July 10, 2015

Addendum No. 1

Deck Replacement, Site and Pool Modifications to Drennan Pool at McAuliffe Park for the Town of East Hartford

POOL PIPING PLAN and DETAILS

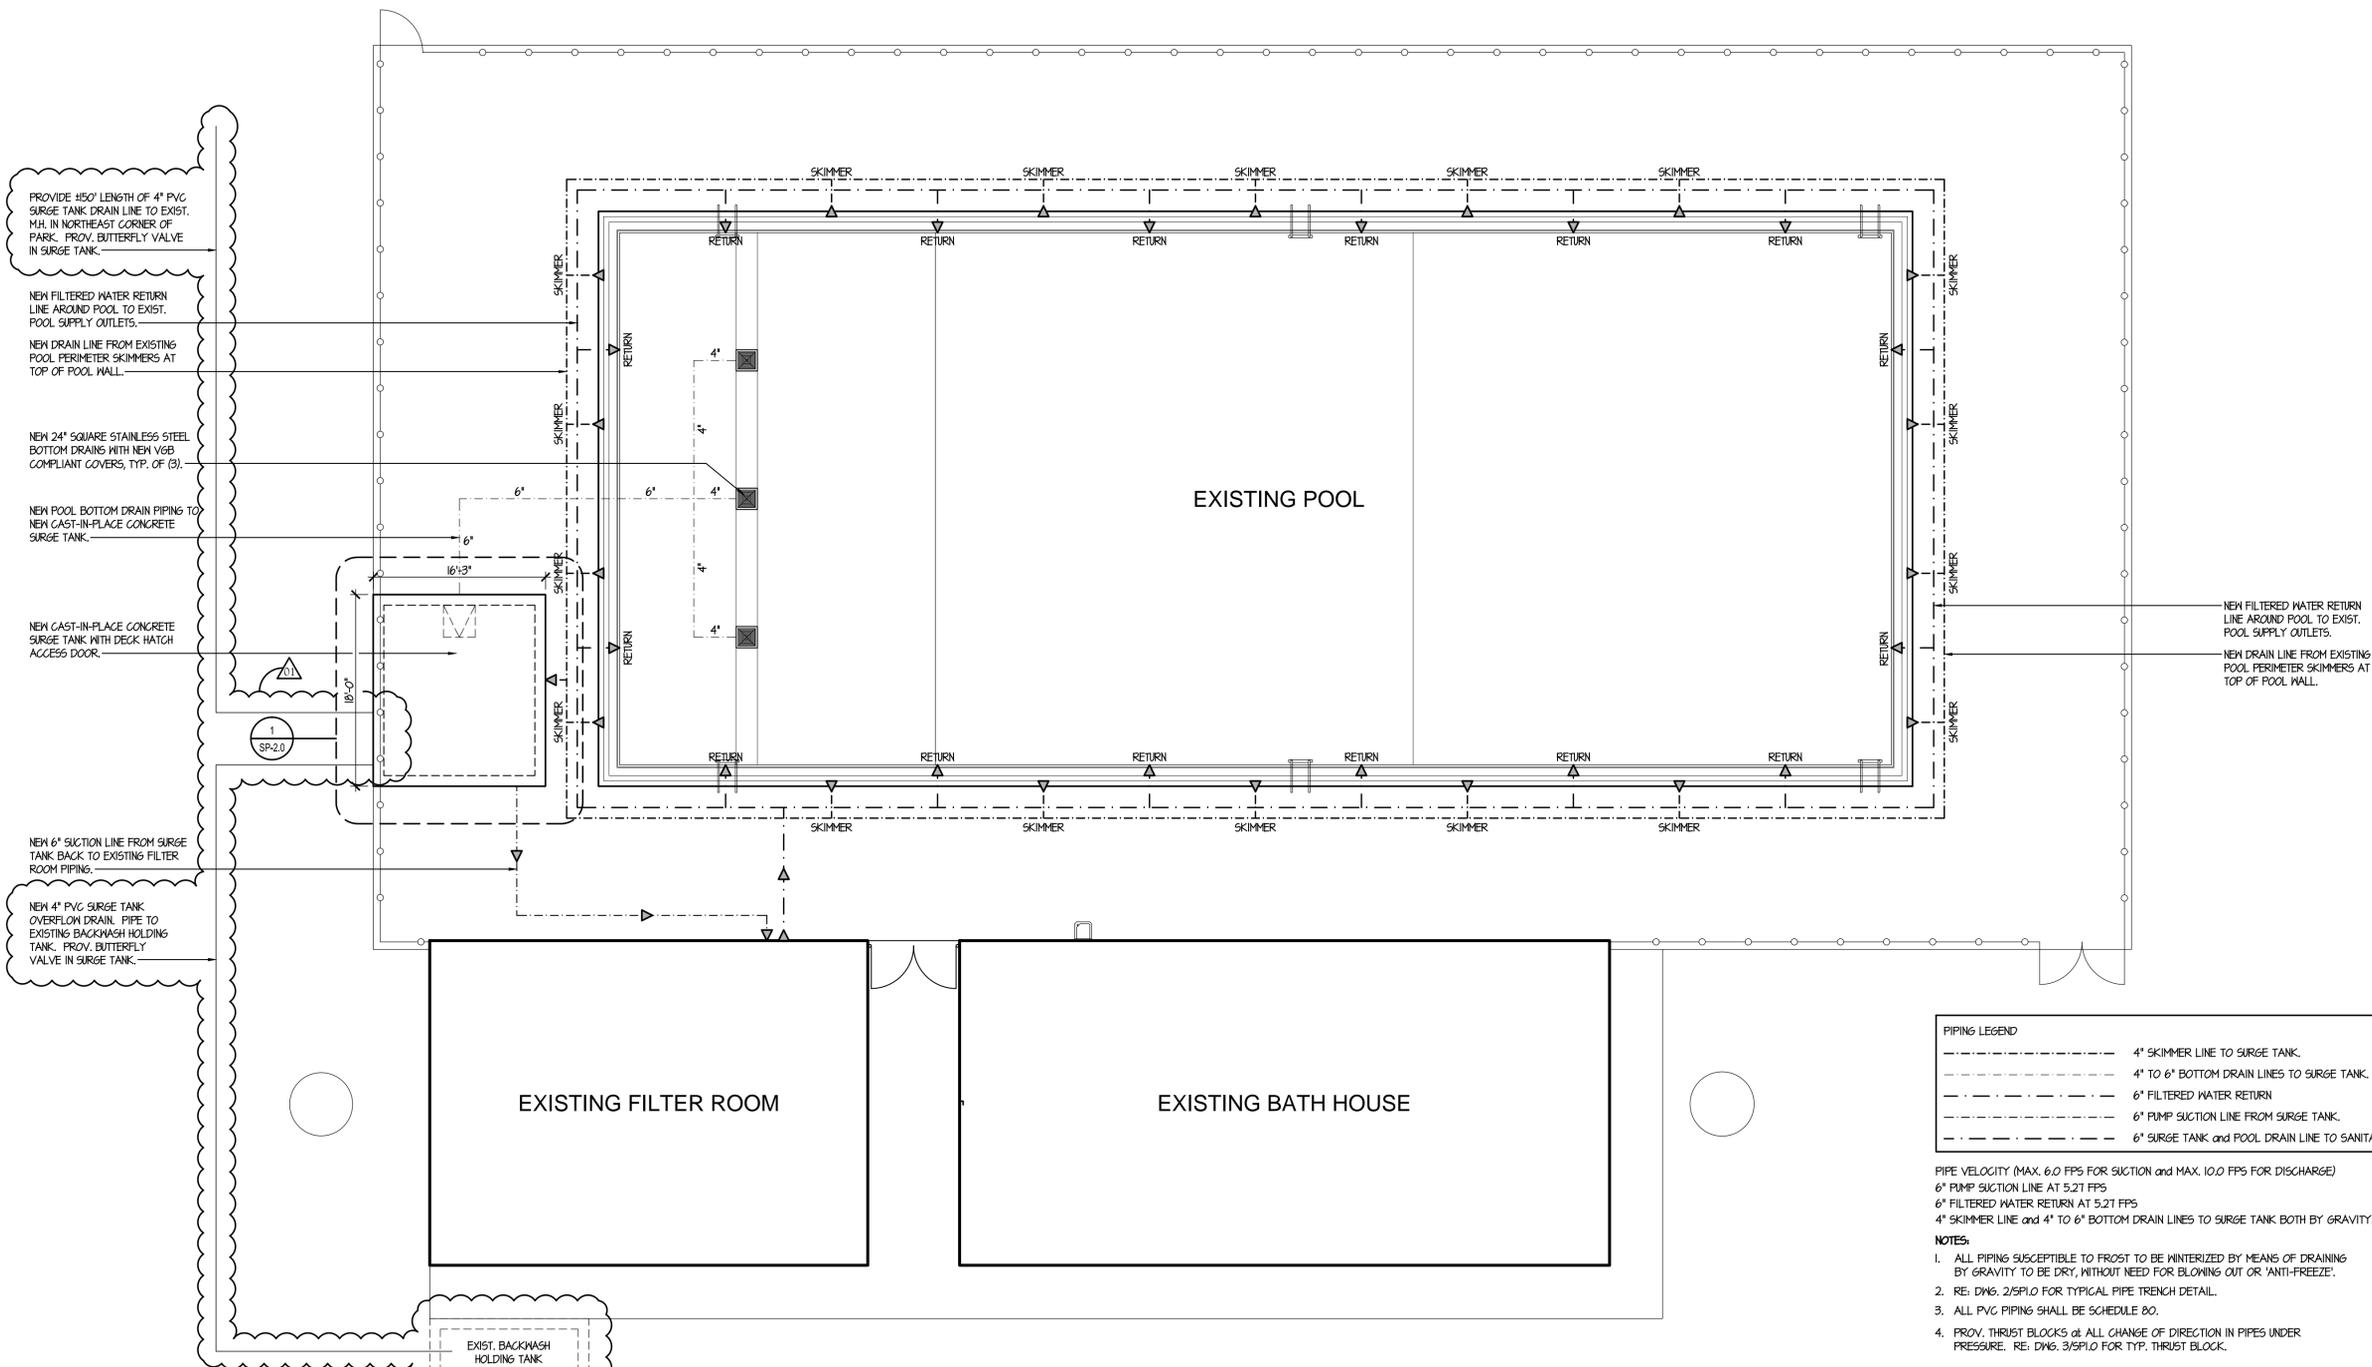
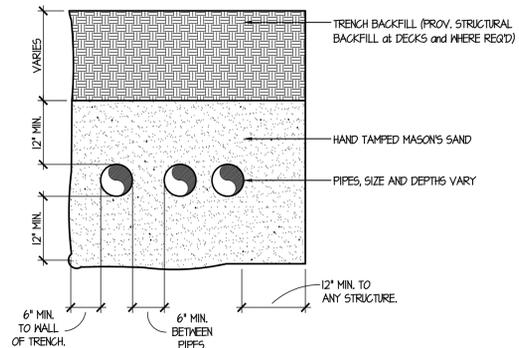
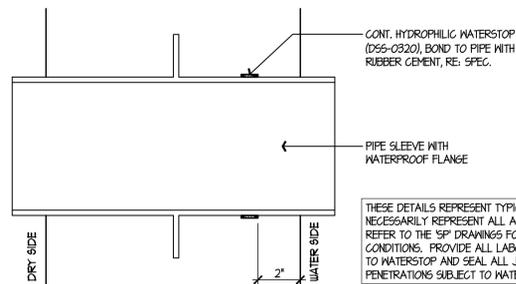
07/10/15	Pool drain and notes	01
revisions

SURGE TANK PLAN, SECTIONS and DETAILS

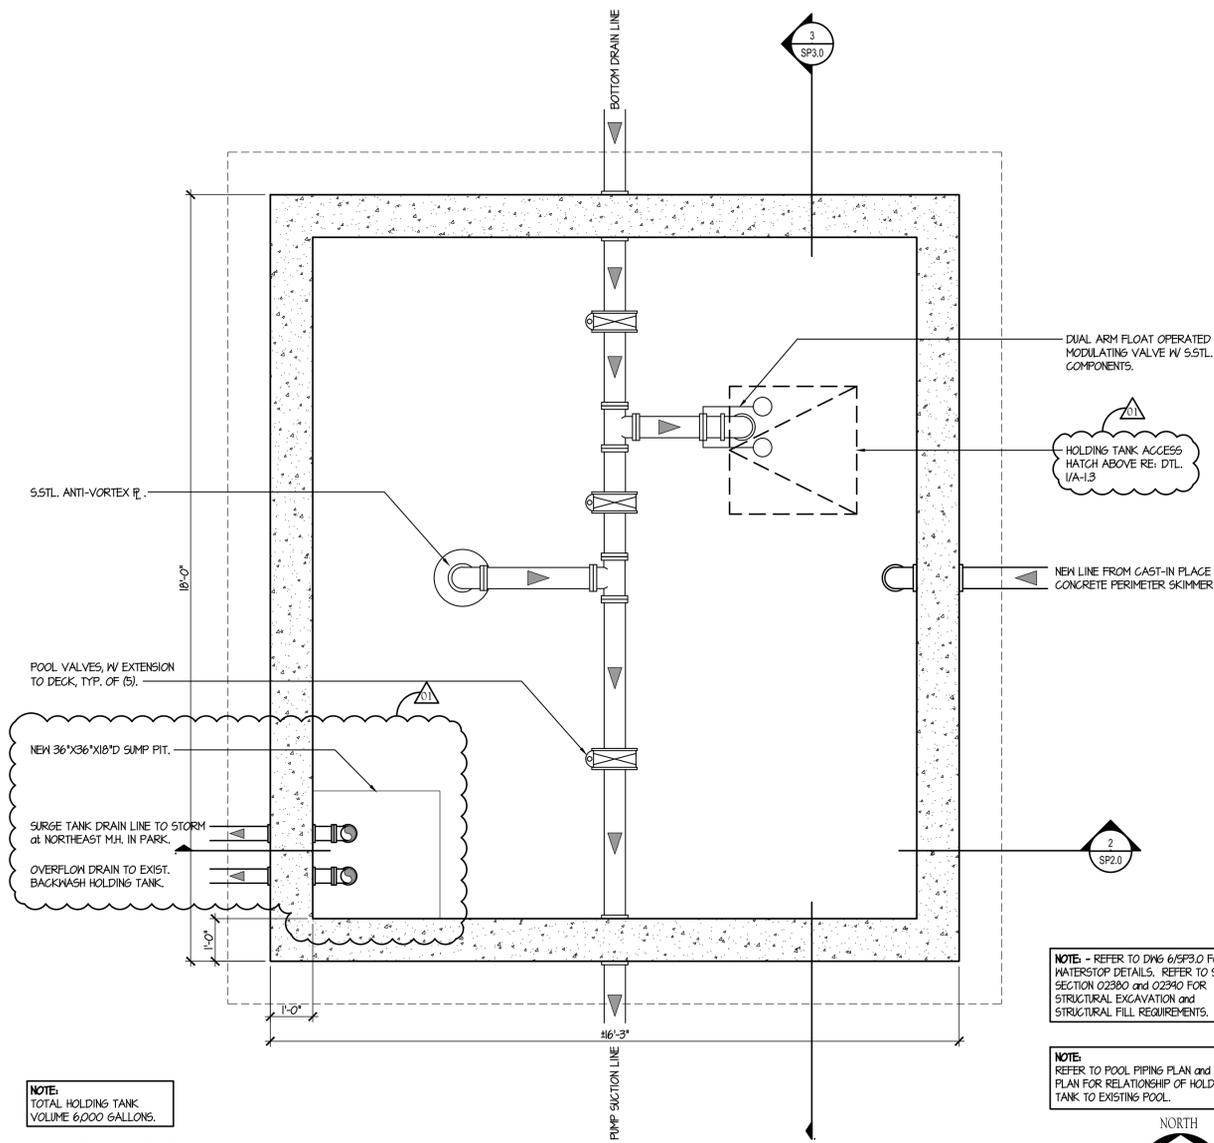
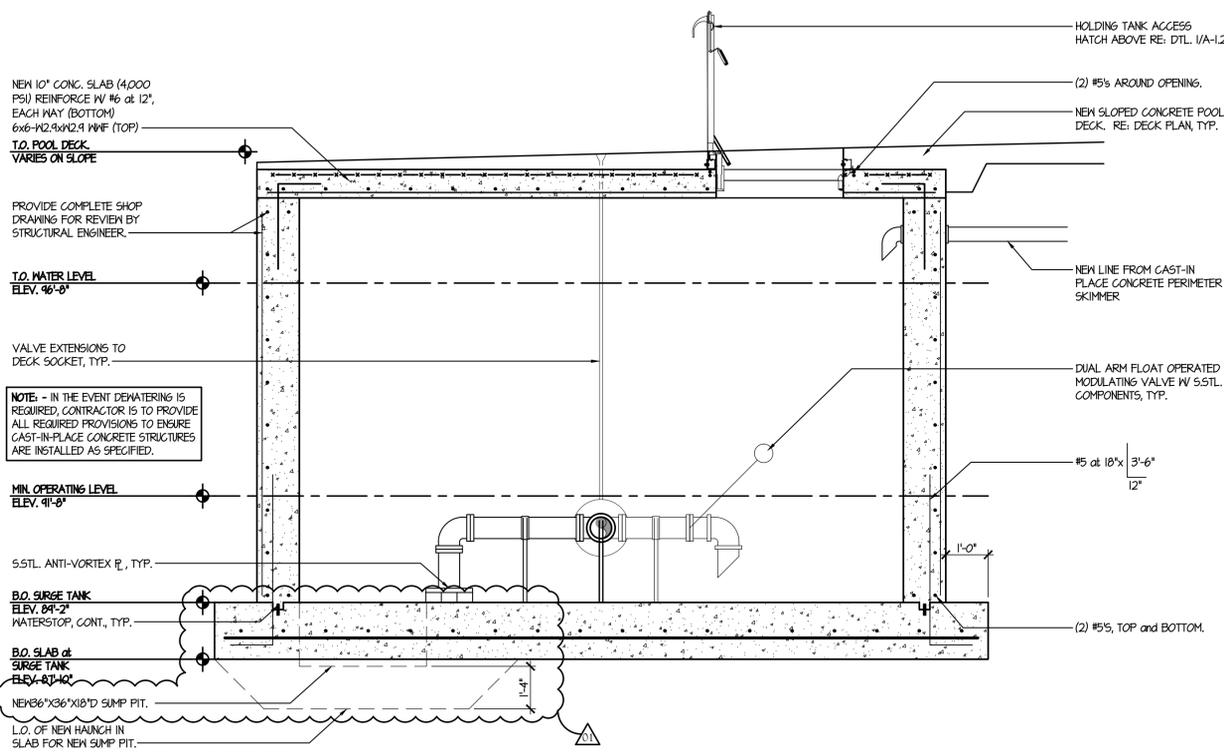
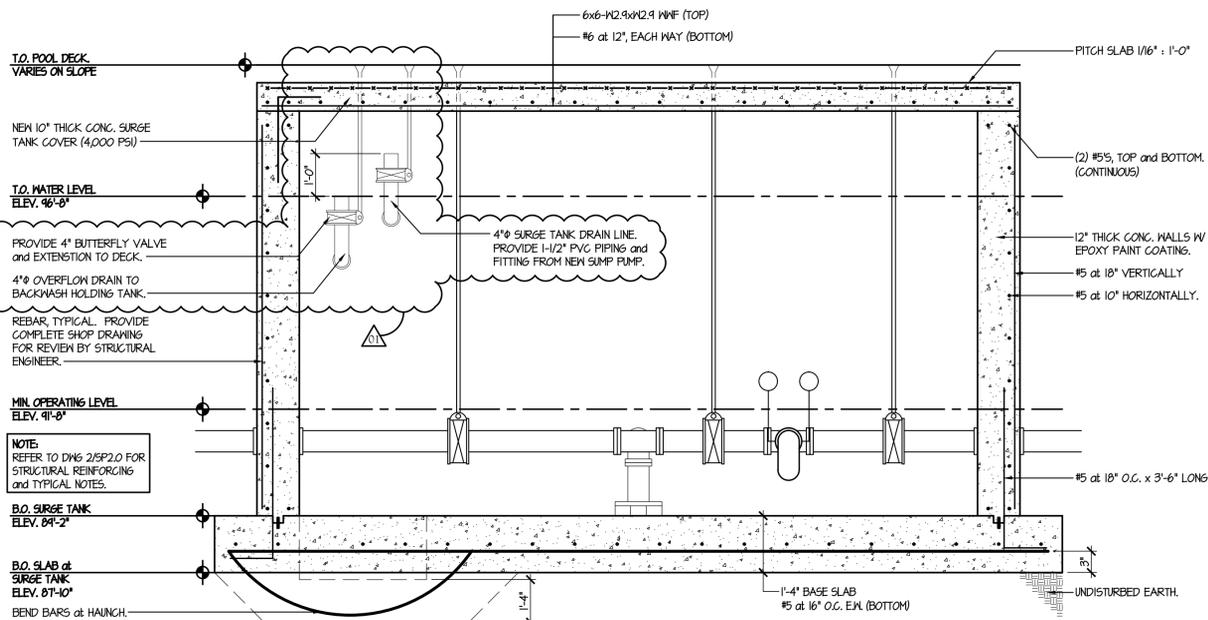
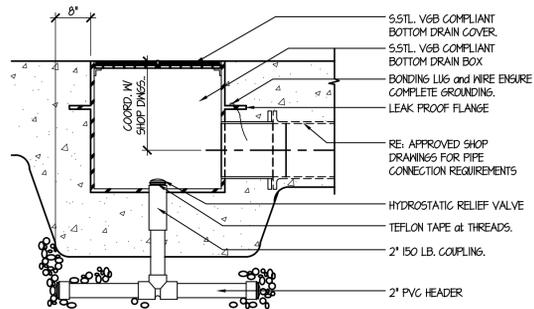
10. Delete all work related to the draining of the swimming pool to sanitary sewer. The pool will be drained as it is now, through the backwash operation. Refer to revised Drawing SP-2.0 (attached).

11. Furnish and install new sump pump for sump pit and surge tank drainage. New sump pump equal to Hydromatic OSP Series OSP50A1. Provide 1-1/2" PVC piping and fittings as required for connection to surge tank drain line. Refer to revised Drawing SP-2.0 (attached).

07/10/15	Pool drain and notes	01
revisions
